Reviews of regulatory settings for official conservation campaigns (OCCs) and the security of supply forecasting and information policy (SOSFIP)

Decision

18 June 2019

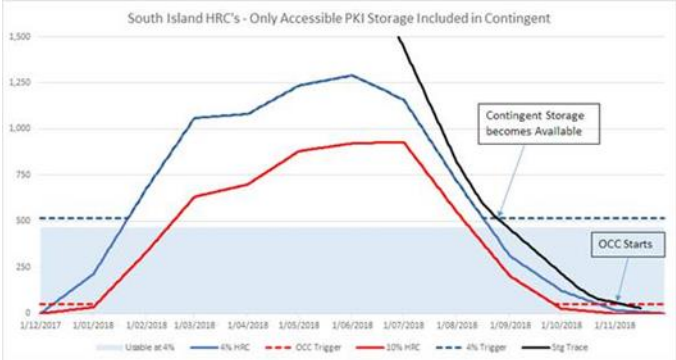
Mercury	Yes for the reasons outlined in the consultation paper para 3.25 (a)-(d). We also agree with the points made in para 3.27 that leaving management to the SO's discretion would provide market participants with less certainty over when contingent storage would be triggered than with a pre-determined buffer. There would also be more incentive for inefficient lobbying of the SO by generators.	Noted
Meridian Energy	<p>Yes, Meridian agrees that a buffer should be added to any HRC floor to avoid the risks identified by the Authority.</p> <p>Hydro lakes may be drawn down unevenly during a very low inflow sequence. Restrictions on draw down rates and transmission constraints could also mean that some hydro storage is not used to generate at the same rate as storage in other lakes. In addition, some generators may consider it prudent to retain minimum volumes of controlled storage to manage the operation of generation plant. There is also the potential for errors in measuring hydro storage. All of these factors may result in some hydro lakes having controlled storage while others do not. The absence of controlled storage in certain hydro lakes, coupled with an inability to access contingent storage (because not all lakes are empty) could have severe adverse consequences for the power system's capacity to meet demand.</p> <p>A buffer margin on top of the floor of total contingent storage available at the 4% HRC would (depending on the size of the buffer) go some way to mitigating the risk of adverse consequences when hydro storage is drawn down unevenly.</p> <p>The size of the buffer is important. We recommend a buffer of at least 100 GWh to account for measurement fluctuations in storage lakes. We suggest a buffer should also be applied above the bottom of all available storage to avoid the risk that an OCC is not called because the 10% HRC cannot be crossed due to uneven draw down of hydro storage. This 10% HRC floor could look like the dashed red line in the figure below:</p>	Noted
